Your Ref: SSD-56264716

Malek Fahd Islamic School Expansion

The following comments are provided for consideration of the Department in the assessment of the subject application. The Department's time limitations mean that these comments highlight high-level issues only based on a limited review by Council staff.

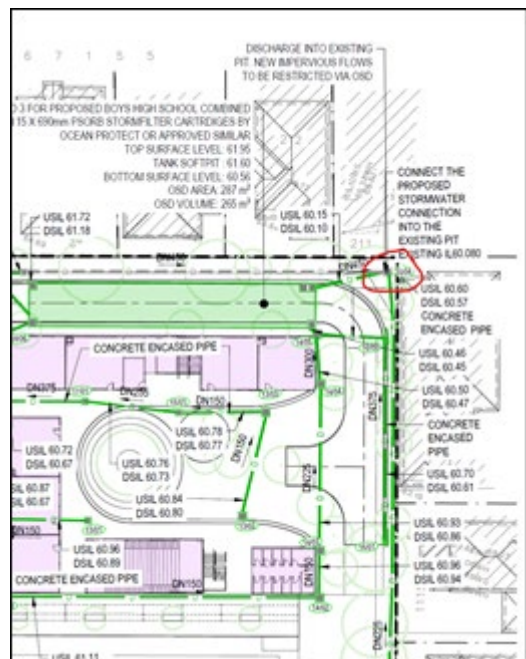
- The Traffic & Parking Assessment prepared by TTPA, dated April 2024, states that the school currently has a maximum capacity of 704 students. However, under the current development consent (891/2023/HC), the school's maximum capacity shall not exceed 600 students as stipulated in Condition 2 of 891/2023/HC:

The applicant is to clarify the current school enrolment numbers and its capacity.
